**LOS ANGELES UNION STATION
FORE COURT AND ESPLANADE IMPROVEMENTS PROJECT**

FINAL ENVIRONMENTAL IMPACT REPORT

| 8.0 | RESPONSE TO COMMENTS ON THE DRAFT EIR..... | 8-1 |

D6-11

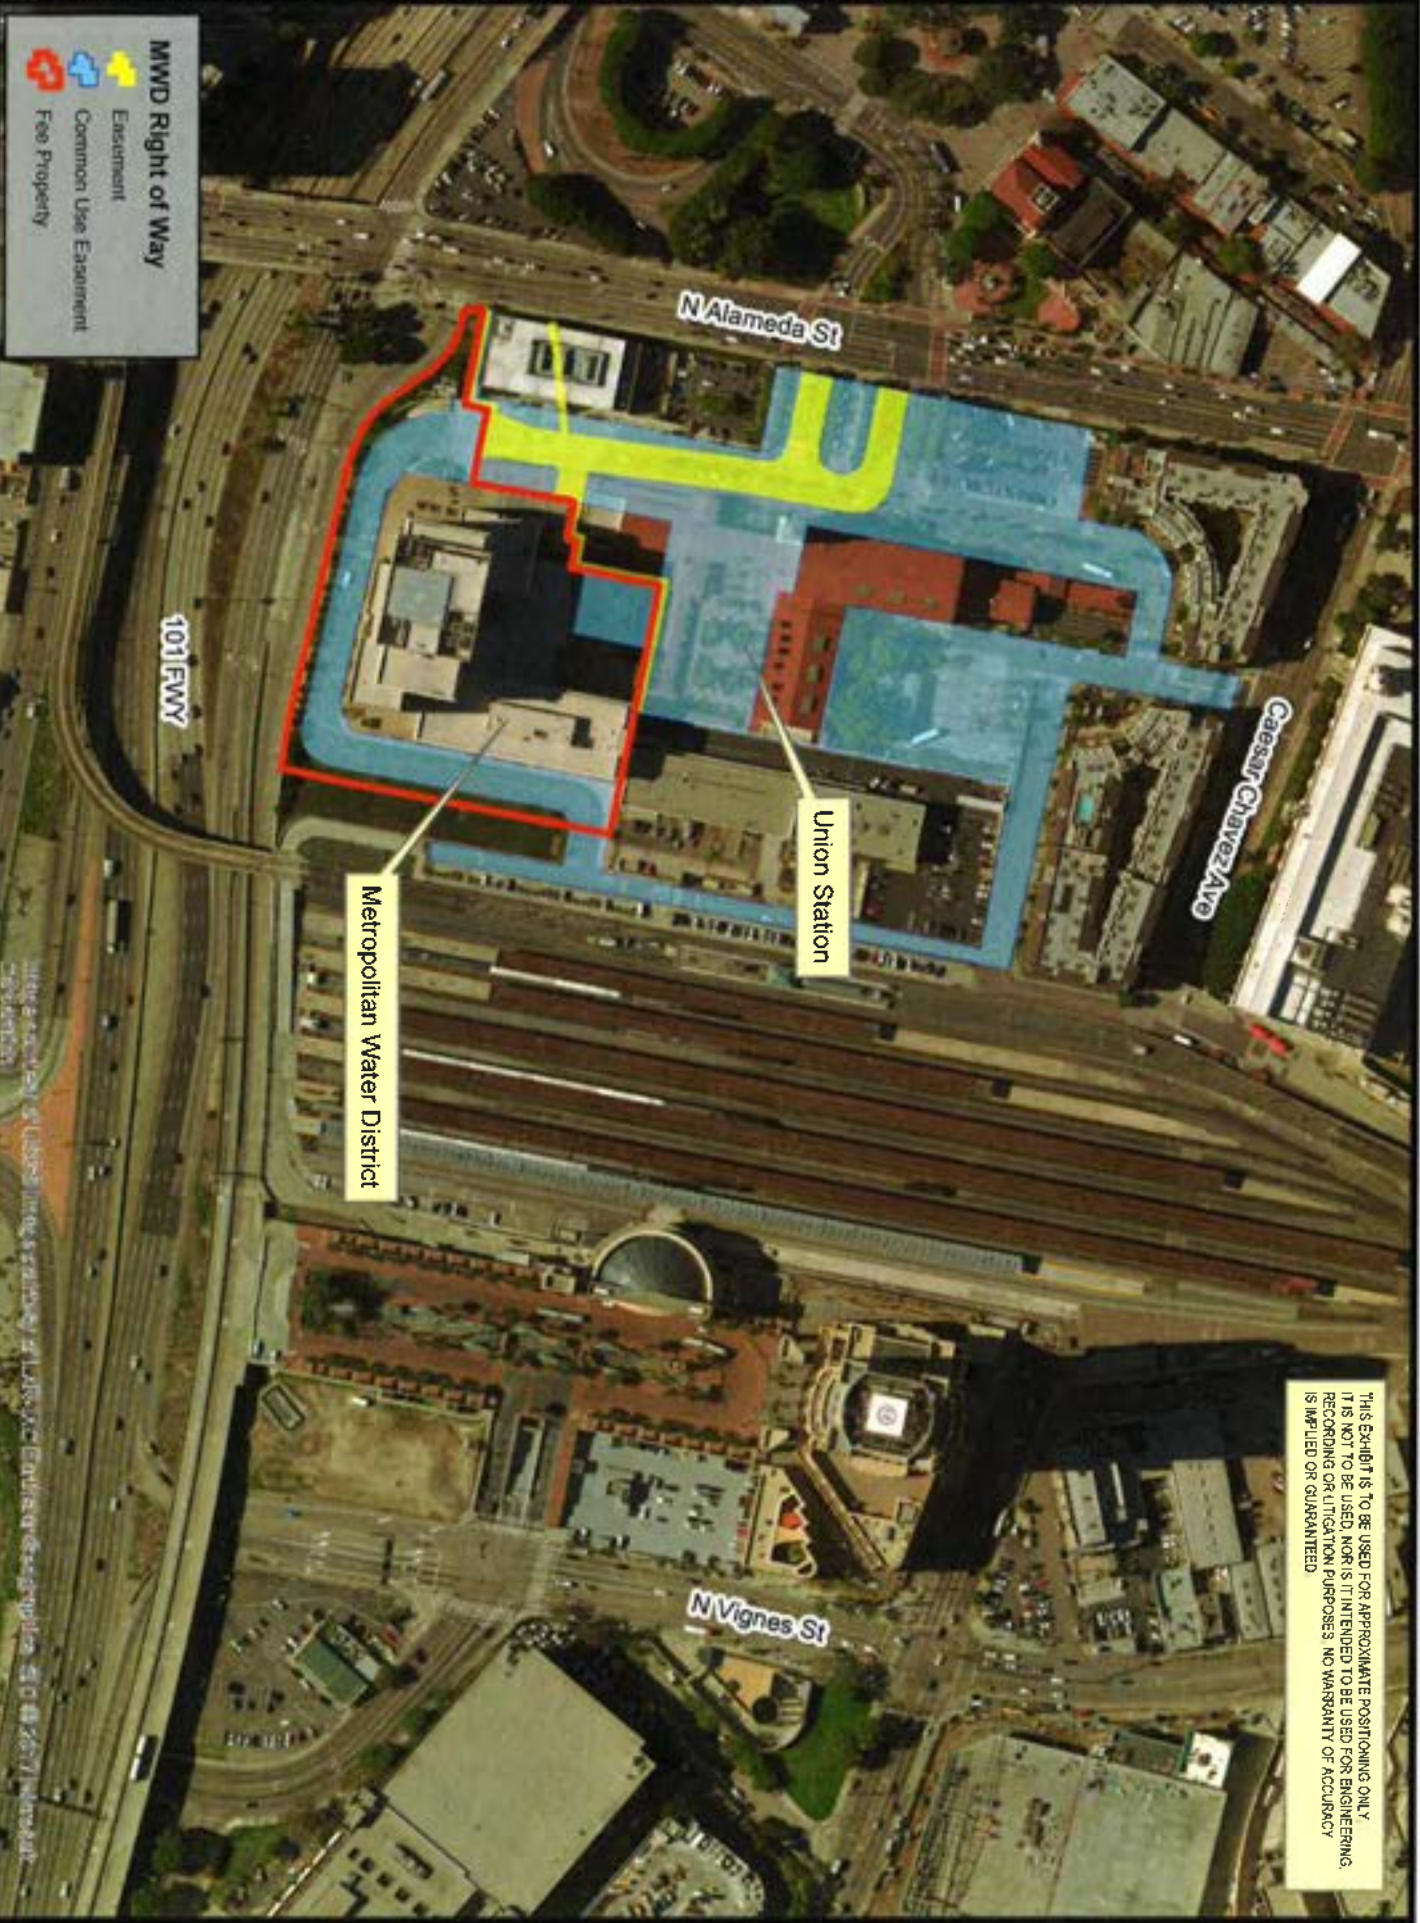
As stated in our prior letter, Metropolitan's approximately 522,682-square-foot building, consists of a 12-story high-rise tower with an attached five-story wing. An exhibit depicting the building and Metropolitan's associated fee property, and permanent and common use easements in relation to Metro's LAUS (under existing conditions) is enclosed for your reference. The HQB's occupants include Metropolitan staff, tenants, and frequent visitors including Metropolitan's Board of Directors and the public. The building's two subterranean parking levels provide 766 vehicle parking spaces distributed amongst these occupants and for Metropolitan's fleet services vehicles. Following are Metropolitan's additional specific comments on the project and DEIR:
